**SECTION 16 APPLICATION
 TOWN PLANNING ORDINANCE (CHAPTER 131)**

**PROPOSED SOCIAL WELFARE FACILITY (RESIDENTIAL CARE HOME FOR THE ELDERLY) IN
 "VILLAGE TYPE DEVELOPMENT" ZONE ON APPROVED NAM SANG WAI OUTLINE ZONING
 PLAN NO. S/YL-NSW/10 AT LOTS 3670 RP (PART), 3671 RP (PART), 3672 RP (PART) AND 3673
 RP (PART) IN D.D.104, NAM SANG WAI, YUEN LONG**

Town Planning Application No. A/YL-NSW/349 - Submission of Further Information (6)

Response-to-Comment Table

Figure Title **LENGTH OF VISIBILITY LINE FOR THE MOTORIST
LEAVING THE PROPOSED RCHE AT KAM POK ROAD EAST**

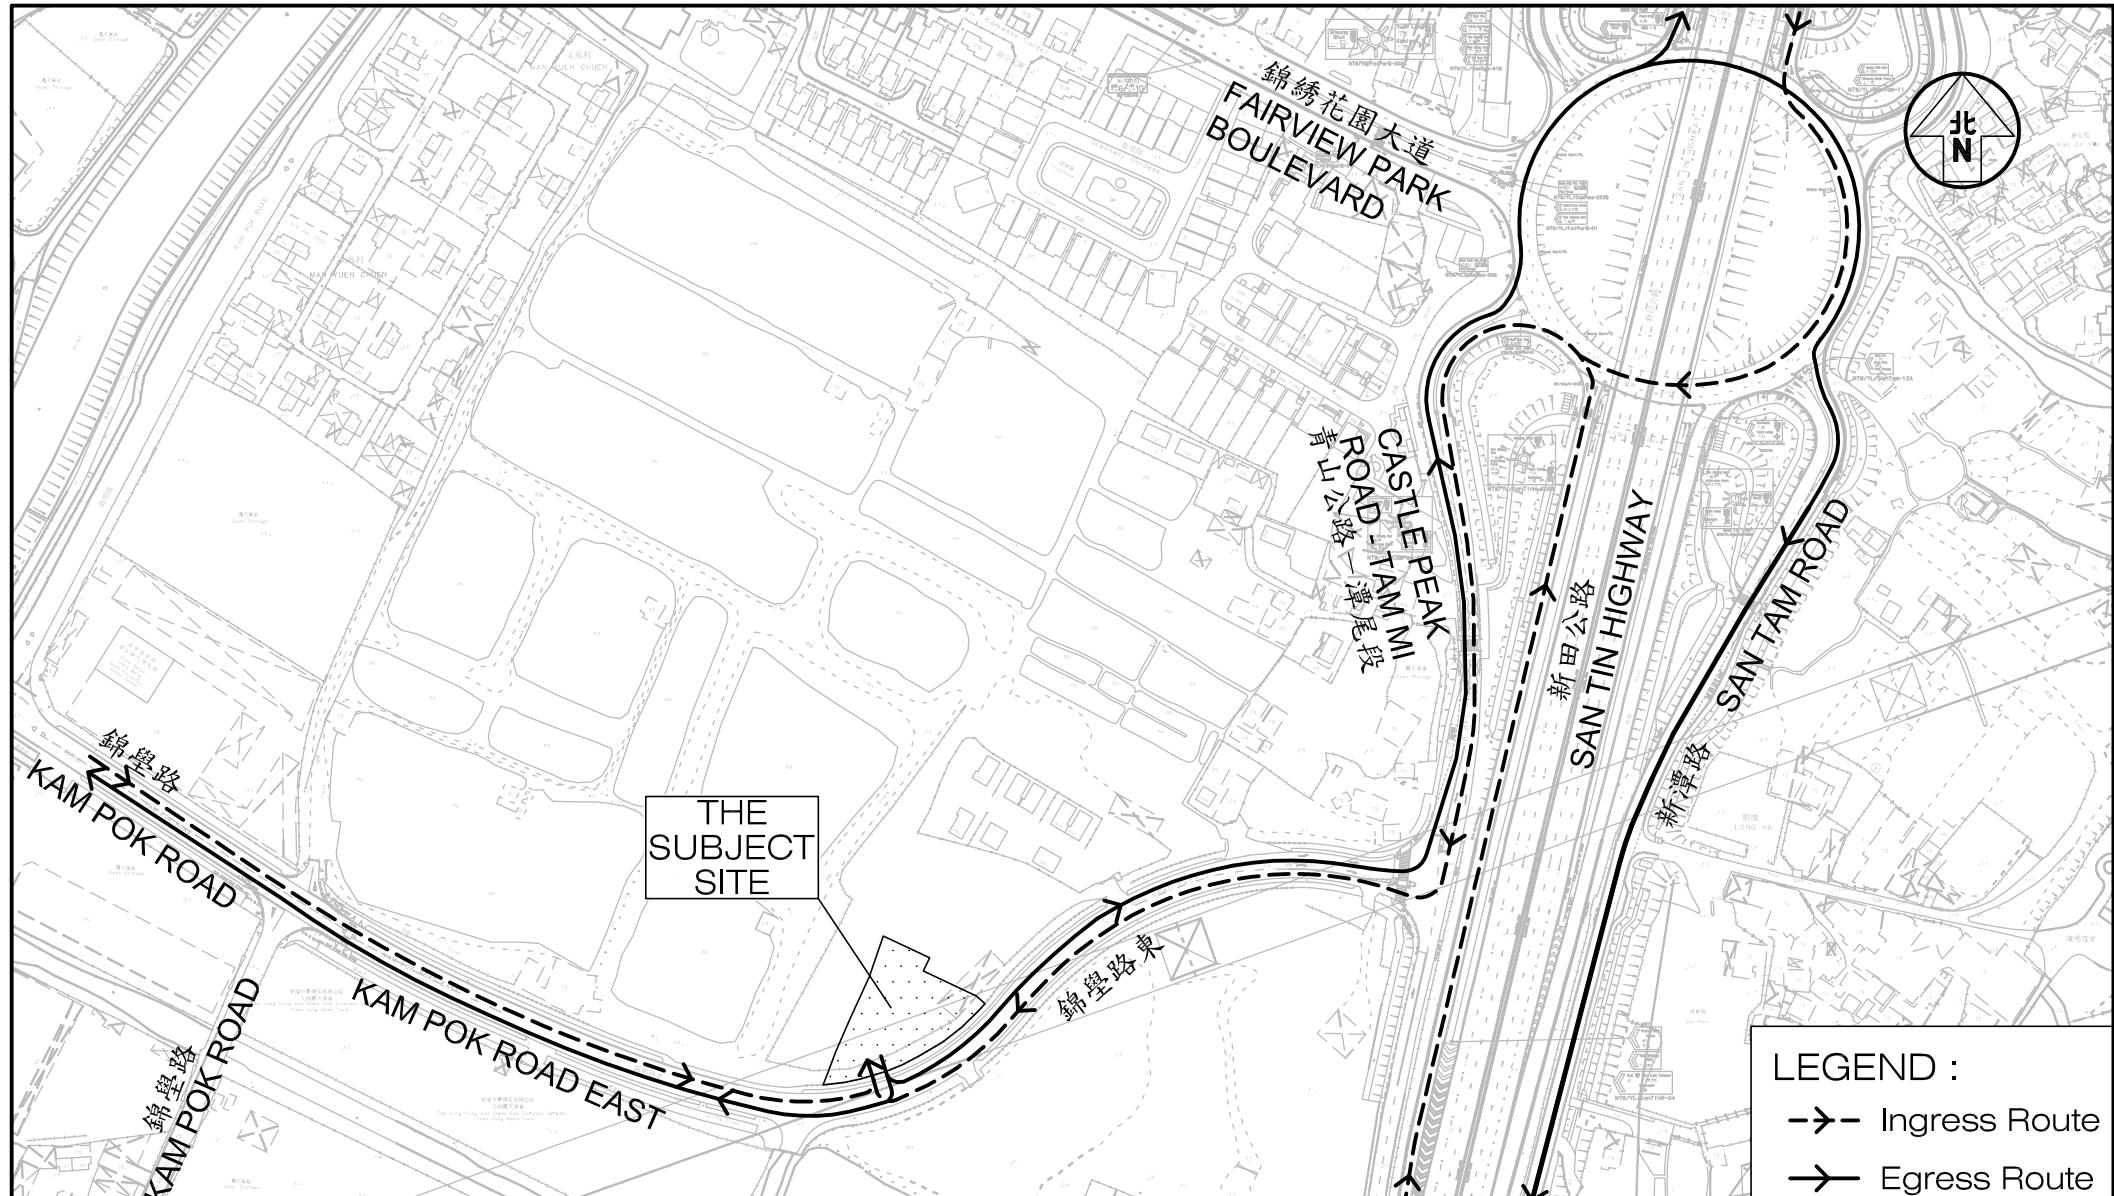
2. Given the congested area at the site entrance, the management staff should be on-site at all time to manage the traffic.	Noted.
3. Re. RtC Item 6: It appears that your checking of visibility splay has not taken into account of the existing planter. Please revisit the checking and demonstrate sufficient sightline could be maintained at all time since the commissioning of RCHE.	In order to ensure the adequate sightline for vehicles and pedestrian, the amendment of existing planter is needed to ensure no obstructions taller than 1.05m will be erected within the visibility splay at the run-in/out.

Noise Barrier and Street Furniture

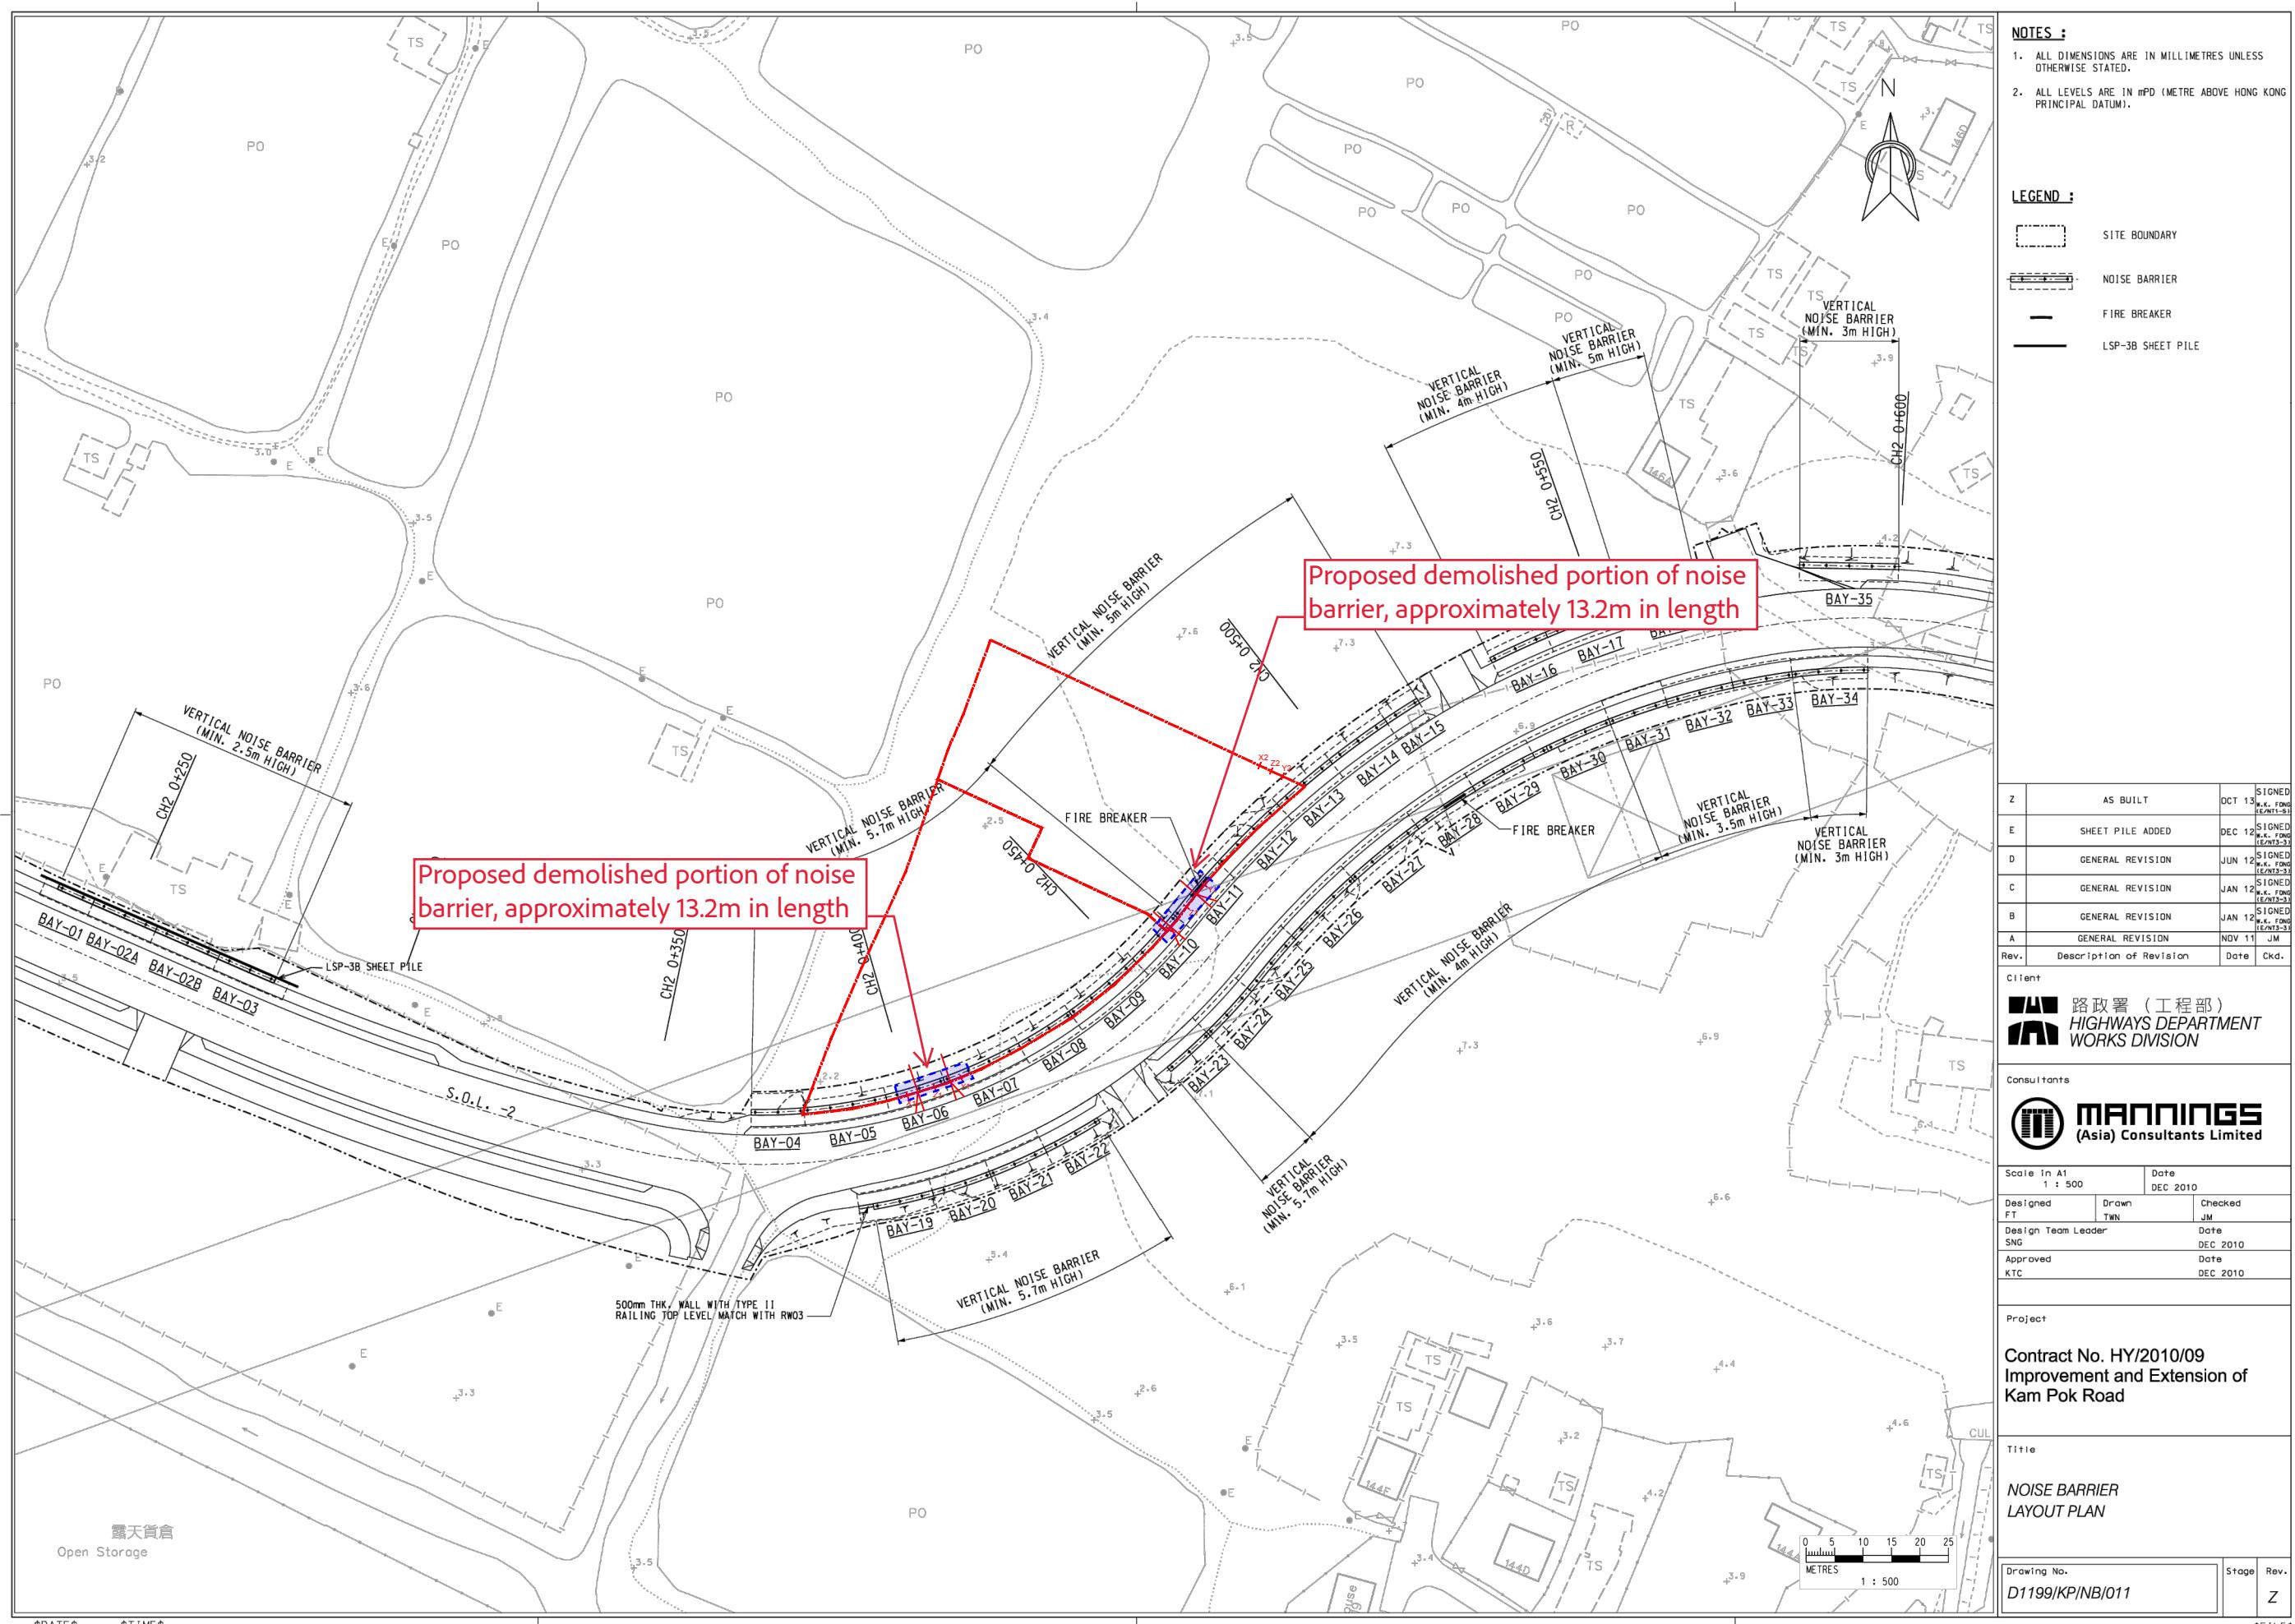
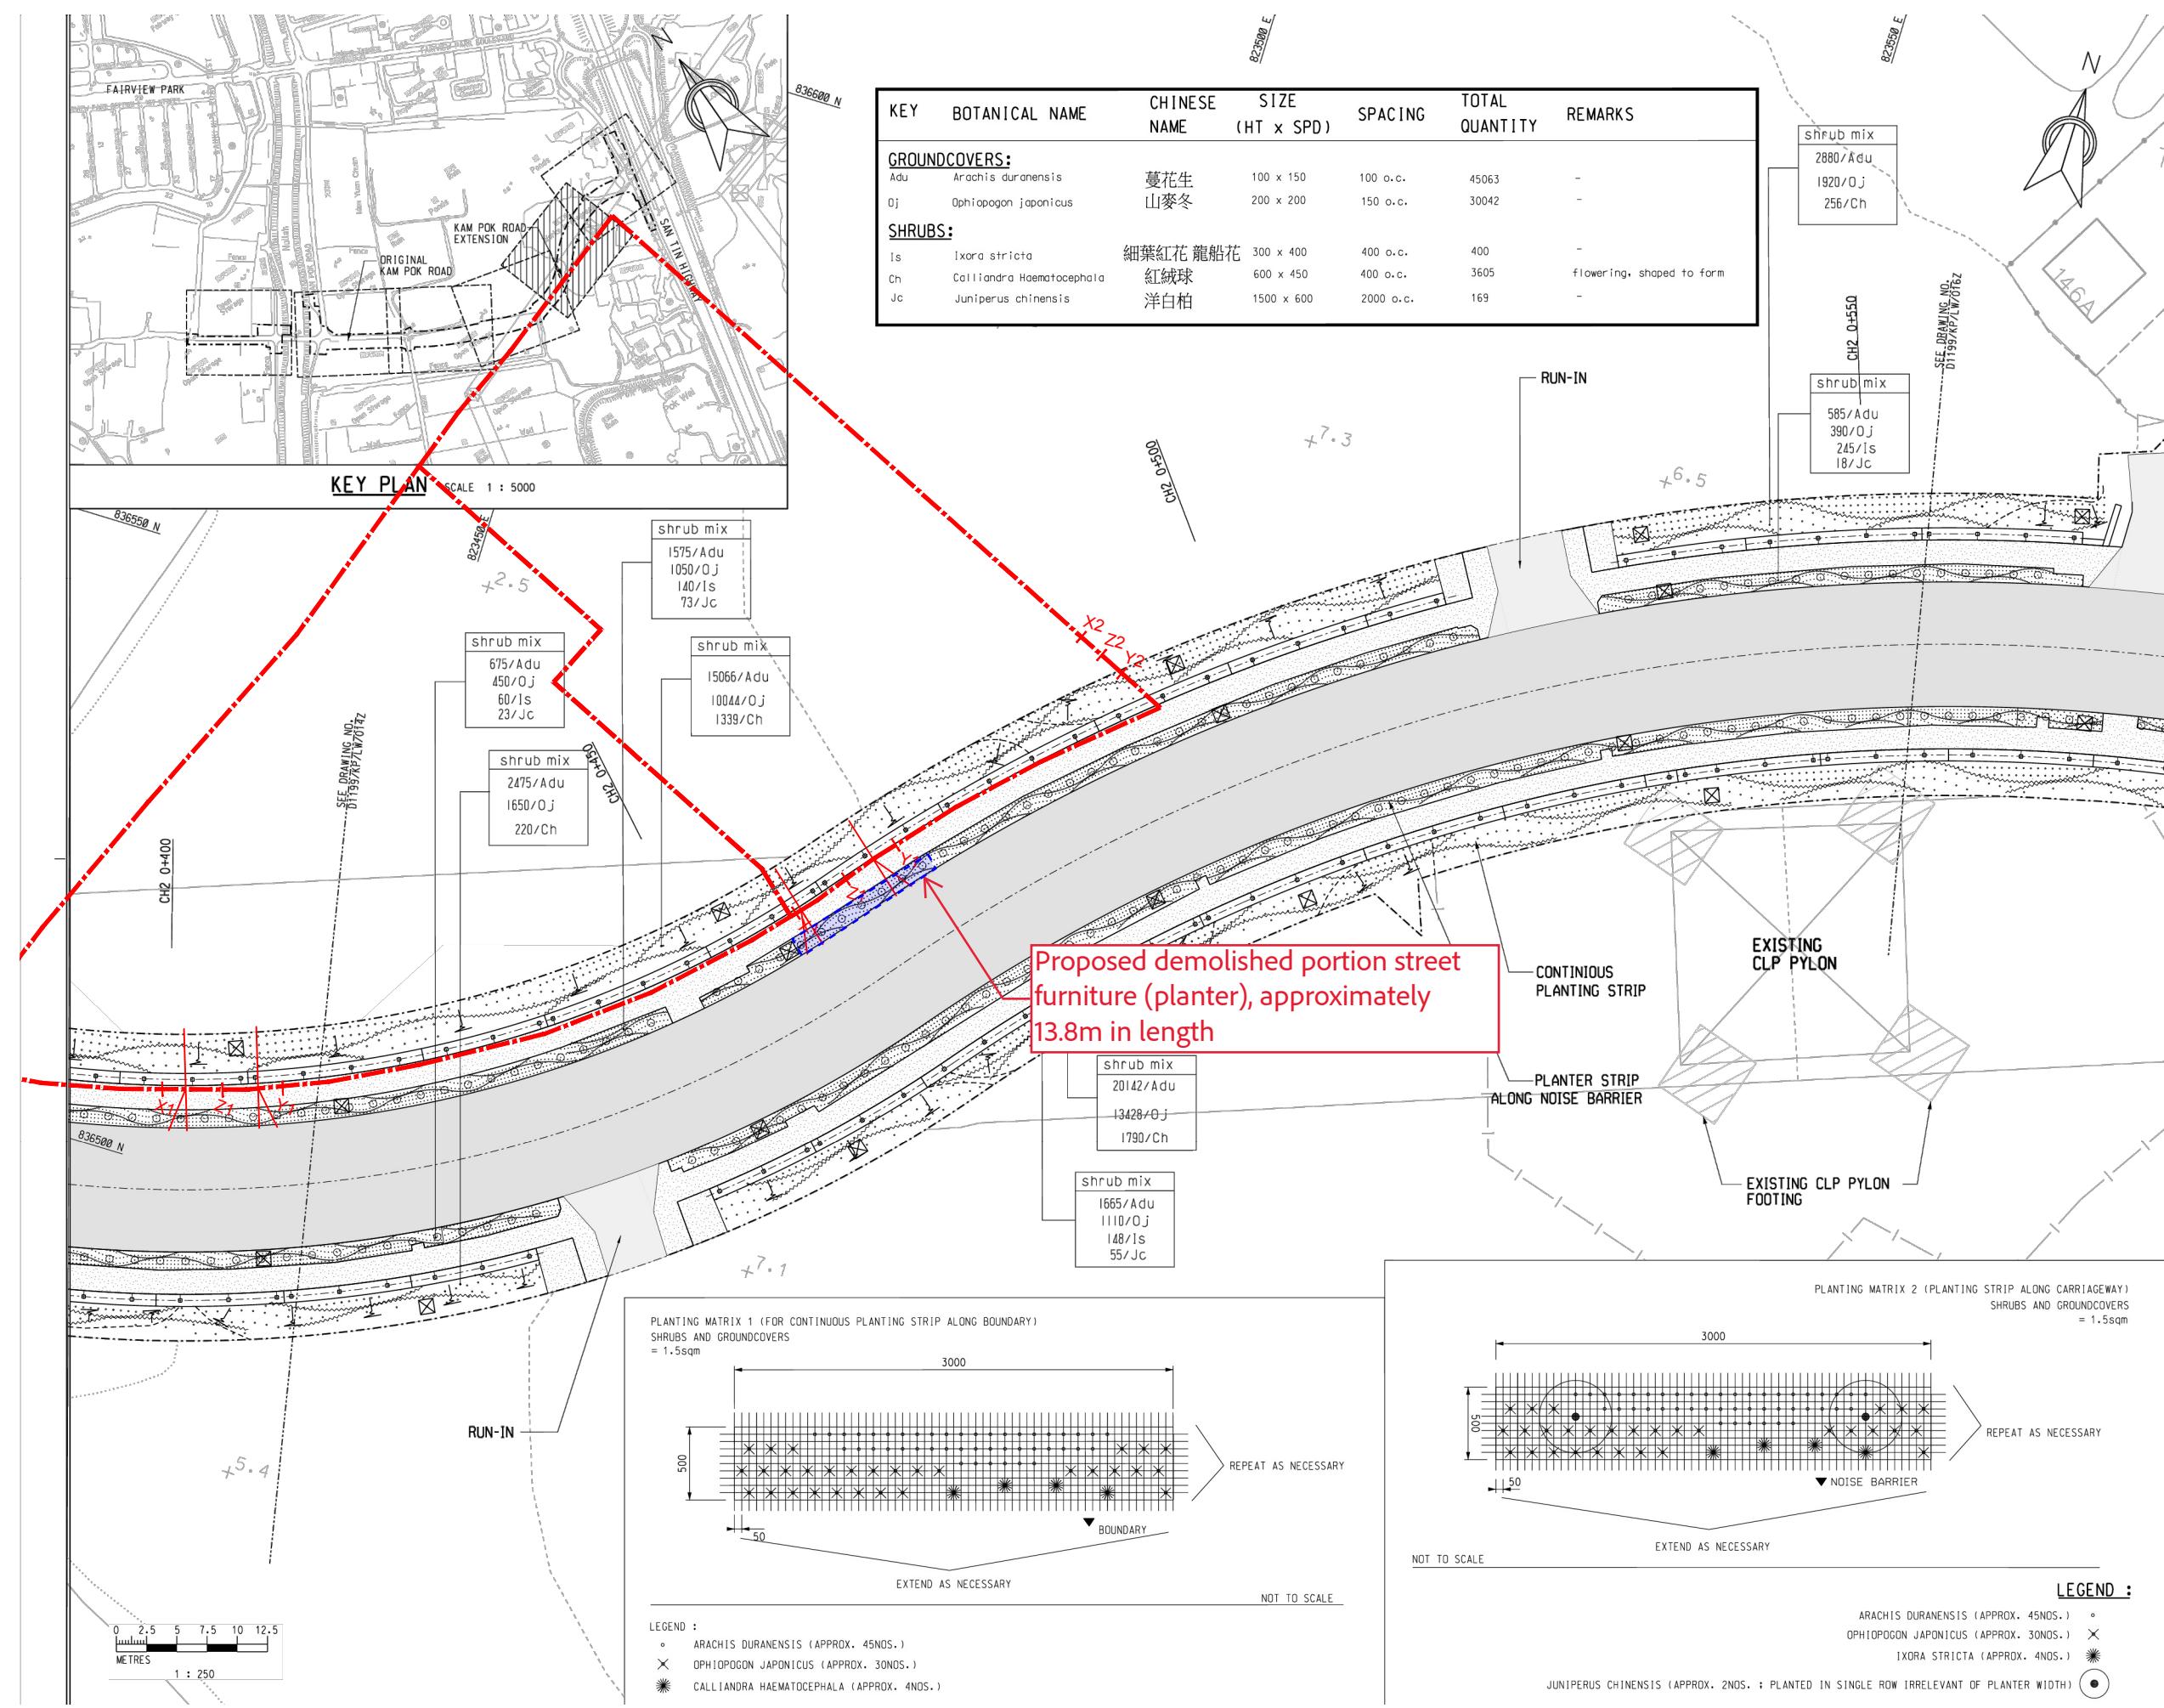
1. Noise Please supplement in the report the reason(s) for the proposed demolition of the existing noise barrier.	See revised Environmental Assessment (Appendix 2). The discussion is provided in Section 3.4.7.

3.	<p>It is noted that the applicant proposes to modify an existing noise barrier for construction of access roads to the application sites. As such, for the sake of completeness, (a) the road traffic noise impact on the proposed development and nearby noise sensitive receivers (NSRs) due the modification of the noise barrier should be addressed and (b) schedule of implementation, for example, to remove the noise barrier only after the RCHD and RCHE are in place, or to provide interim measures (if required) to mitigate road traffic noise impact to nearby NSRs should be provided in the noise impact assessments in the updated EAs. Also, the applicant should (c) provide TD's endorsement on the traffic data adopted in the updated NIAs and (d) ensure the separated cells of the dormitory should not be divided by full-height partitions.</p>	Noted with thanks.
